Office Action Summary

09/855,853

MURRY ET AL. *CK*

DETAILED ACTION

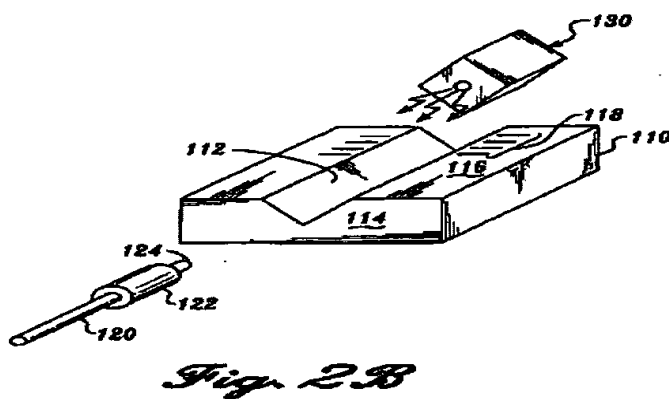
Claims 62,64,70 and 71 are rejected under 35 U.S.C. 102(b) as being anticipated by Beranek et al (PN 5,896,481).

In figure 2B Beranek et al illustrates a silicon optical bench (110) having an etched groove (112) for mounting and aligning a vertical cavity surface emitting laser (VCSEL) with an optical fiber (120), which receives the emitting laser beam of the VCSEL. The emitted beam is parallel with the optical bench and is directly coupled with optical fiber.

FIG. 6

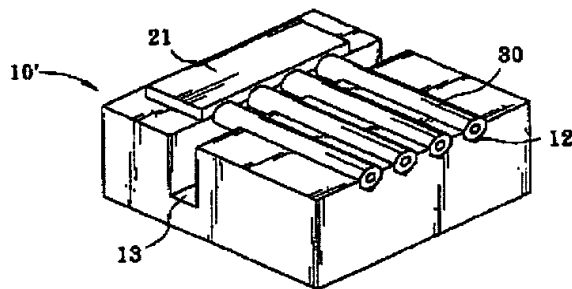
In figure 6 Wu et al illustrates an array of vertical cavity surface emitting lasers (21) mounted on a slot (11) (not shown see figure 2 and an array of optical fibers (30), where the lasers and the fibers are all mounted on a silicon substrate. The lasers emit a light, which is optically coupled to the edge of the fiber.

Therefore, it would have been to a person having ordinary skill in the art at the time the invention was made to duplicate the alignment structure of Beranek et al as

taught by Wu et al to obtain an array of VCSEL aligned with optical fibers for receiving the emitted laser beam.
